From: [Mayton, Dennis H.](#)
To: [Brad Stephenson](#); [Froede, Carl](#)
Cc: [Maki, Mark \(CONTR\)](#); [Primrose, Annette L](#); [Linton, Jennifer](#); [Petrie, Roger](#); [Randy Young](#)
Subject: [EXTERNAL] Responses to TDEC comments on the EMDF Baseline Monitoring Plan for Groundwater and Surface Water
Date: Monday, August 14, 2023 10:17:23
Attachments: [B85_EM_DISP_FACILITY_R3.pdf](#)
[Baseline GW and SW FSP D2 TDEC RTC 8-14-23.pdf](#)

Document Number: DOE/OR/01-2812&D2	Document Title: <i>Field Sampling Plan for Baseline Groundwater and Surface Water Characterization at the Proposed Environmental Management Disposal Facility, Oak Ridge, Tennessee</i>		
Name of Reviewer: Randy Young	Organization: TDEC	Date Comments Transmitted: 10-21-2022 & 04-21-2023

**ENVIRONMENTAL MANAGEMENT
DISPOSAL FACILITY**

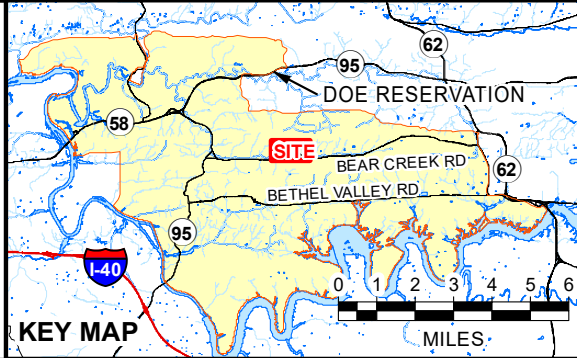
The figure was revised to add the sampling location at the confluence of NT-11 and Bear Creek.

4	Fig. 3 pg 8	<p>a. As acknowledged on page 4 and consistent with various DOE publications, a component of EMDF groundwater flow likely moves toward the west (grid direction) or southwest (true direction) along the geologic strike of the fractured bedrock and saprolite. TDEC expects the future detection monitoring well network will include at least three shallow/deep well pairs along the western/southwestern landfill boundary. Therefore, TDEC recommends another shallow/deep well pair in the baseline monitoring network near the northwestern/western corner of the landfill footprint-Le., uphill from the planned location of GY-033/034.</p> <p>Additional TDEC comment (4/21/23):</p> <p>Comment unresolved. TDEC urges DOE to plan toward a RCRA-compliant detection monitoring network that avoids delays in finalizing design documents and initiating landfill operations. Toward that end, TDEC supports consideration of baseline well locations that maximize their cost-effective reuse during future detection and closure monitoring programs, where possible.</p> <p>b. Are any of the existing site characterization piezometers-not</p>	<p>a. Clarification provided. Consideration of detection monitoring wells will be deferred until the detection monitoring network is established to avoid interference with landfill construction activities.</p> <p>Response to additional TDEC comment (4/21/23)</p> <p>Agree. The baseline well locations were intended to be reused as part of the future detection monitoring program. They do not represent the entire detection monitoring network that will be established during the final landfill design.</p> <p>b. Clarification provided. The site characterization</p>

Comment No.	Sect/ Page	Comment	Response
		<p>shown on the map suitable for baseline groundwater sampling? Piezometer construction information presented in TM-2 suggests they may fit for sample collection.¹ Some existing piezometers appear to be outside the planned landfill footprint. If those piezometers are not used for baseline groundwater sampling, DOE should consider continuing groundwater level recording at those locations to support baseline monitoring and the groundwater field demonstration.</p> <p>Additional TDEC comment (4/21/23):</p> <p>Comment resolved, but TDEC requests a copy of the ORR [Oak Ridge Reservation] monitoring well requirements cited in the response. Presumably, this is the <i>Standard Specification for Well Drilling, Installation, and Abandonment</i> (SPG-00000-A005) cited in Section 3.1 (p. 12).</p> <p>c. Add a north arrow, and indicate whether it represents true north or grid north.</p> <p>Additional TDEC comment (4/21/23):</p> <p>Comment resolved; no further response required.</p> <p>d. Define the polygons in the legend.</p> <p>Additional TDEC comment (4/21/23):</p> <p>Comment resolved; no further response required.</p> <p><small>¹ Technical Memorandum #2, Environmental Management Disposal Facility Phase 1 Monitoring, Oak Ridge, Tennessee (DOE/OR/01-2785&D1) and Responses to Comments on Technical Memorandum #1, Environmental Management Disposal Facility Phase 1 Monitoring, Oak Ridge, Tennessee (DOE/OR/01-2785).</small></p>	<p>piezometers will not be used for baseline monitoring because these do not meet the requirements for an ORR monitoring well. Piezometers continue to be used for groundwater level recording, but will be plugged and abandoned when landfill construction activities begin.</p> <p>Response to additional TDEC comment (4/21/23)</p> <p>Agree. This specification has been provided.</p> <p>c. Agree.</p> <p>d. Clarification provided. The proposed sediment basins were removed and the figure was updated to match the current design configuration.</p>

Comment No.	Sect/ Page	Comment	Response
		<p>a new station at the NT-10 confluence. TDEC supports the plan to sample surface water in NT-10 and NT-11 to support detection and/or operational monitoring and in case landfill wastewater is eventually discharged to one or both streams.</p> <p>Additional TDEC comment (4/21/23): Comment unresolved.</p> <p>a) TDEC requests additional clarification whether DOE plans to characterize baseline conditions in NT-10 and NT-11. Available information includes the following.</p> <ul style="list-style-type: none"> • Response 6 includes language that appears contradictory. <ul style="list-style-type: none"> ○ One sentence states, "The EMDF does not plan to discharge to NT-10 or NT-11, therefore, baseline sampling is not required." ○ Another sentence, also included on p. 14 of the revised document, states, "Surface water sampling will occur at three locations: flumes SF-1 located on NT-11, and SF 6 located on NT-10 ... , and the existing Bear Creek monitoring station at the NT-11 confluence with Bear Creek." • DOE Response 6 states, "Baseline data will be collected from Bear Creek at the NT-11 confluence ... ," but Figure 3 shows only two baseline surface water monitoring locations: NT-10 (SF-6) and NT-11 (SF-1). No locations are shown for Bear Creek. • DOE Response 6 states, "The EMDF does not plan to discharge to NT-10 or NT-11, therefore, baseline sampling is not required." However: <ul style="list-style-type: none"> ○ Text on p. 1 states, "Surface water monitoring is included because groundwater from the uppermost aquifer primarily discharges to surface water features." ○ Text on p. 3 states, "Groundwater within the saturated zone converges and discharges slowly into NT stream channels supporting base flow along the valley floors, particularly during the wet season." ○ Figure 3 shows baseline surface water monitoring 	<p>characterization project, and the existing Bear Creek monitoring station at the NT-11 confluence with Bear Creek."</p> <p>Response to additional TDEC comment (4/21/23):</p> <p>a) See responses to specific bullets below.</p> <ul style="list-style-type: none"> • Agree. See revised response 6 above. • Agree. Figure 3 was revised to show the Bear Creek monitoring locations. • See revised response above.
